FORD:

2015-2016 Mustang

ISSUE

Some 2015-2016 Mustang vehicles equipped with a 2.3L GTDI engine may exhibit a heavy continuous blue smoke with a burning oil smell after idling 10 minutes or longer.

Figure 2 - Article 15-0192

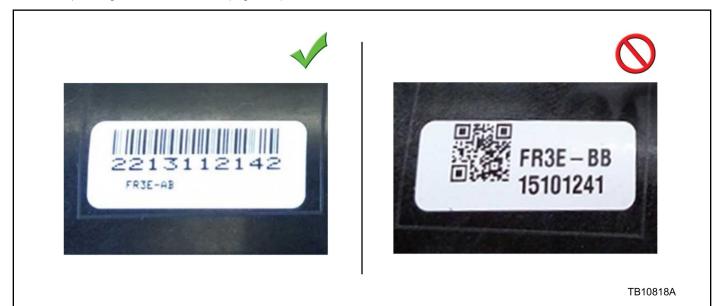
2. Does the part tag have a bar code? (Figure 2)

- a. No this article does not apply. Refer to Workshop Manual, Section (WSM), Section 303-00 for normal diagnosis.
- b. Yes this vehicle is not equipped with a high flow crankcase vent oil separator system. Proceed to Step 3.
- 3. Replace the crankcase vent oil separator. Refer to Workshop Manual, Section 303-08.
- 4. Reprogram the powertrain control module (PCM) to the latest calibration using IDS release 98.03 or higher. Make sure you are connected to the internet when entering module programming to obtain the latest updates. Calibration files may also be obtained at www.motorcraftservice.com
 - a. When the IDS tool prompts the question: Is vehicle equipped with FR3E-6A785-BB or later crankcase vent oil separator? Answer; Yes to make sure the vehicle is updated with the correct level PCM software.
